LiDAR Quality Assurance (QA) Report  
Louisiana LiDAR ARRA Project - Region 1  
November 15, 2011

Submitted to:  
USGS

Prepared by:  
 **Dewberry**

Figure 33- A water artifact identified during the visual DEM review. A total of two such artifacts were identified. Tile 15RXN615625.

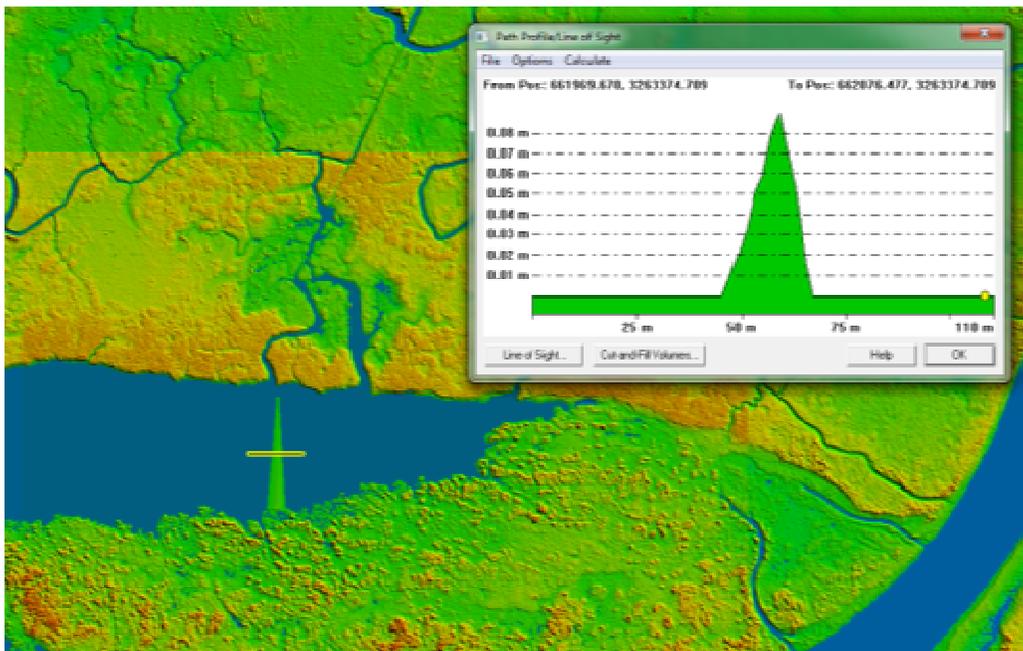
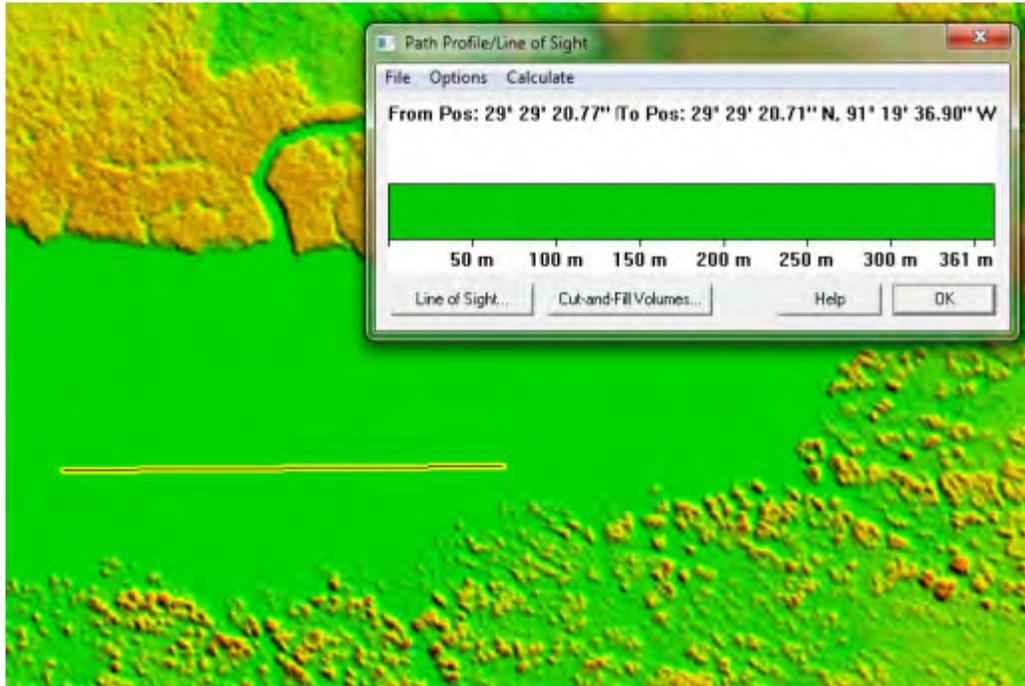
These issues are likely related to the breaklines and the classification to water step, but they are clearly identified in the DEMs and therefore mentioned here. Dewberry identified several areas of water that are in the ground. These areas affect the quality of the ground and should be addressed by Woolpert. Both water artifacts were corrected by Woolpert in the third delivery of the data.

Figure 34- The water artifact identified during the visual DEM review has been corrected in the third delivery. Tile 15RXN615625.
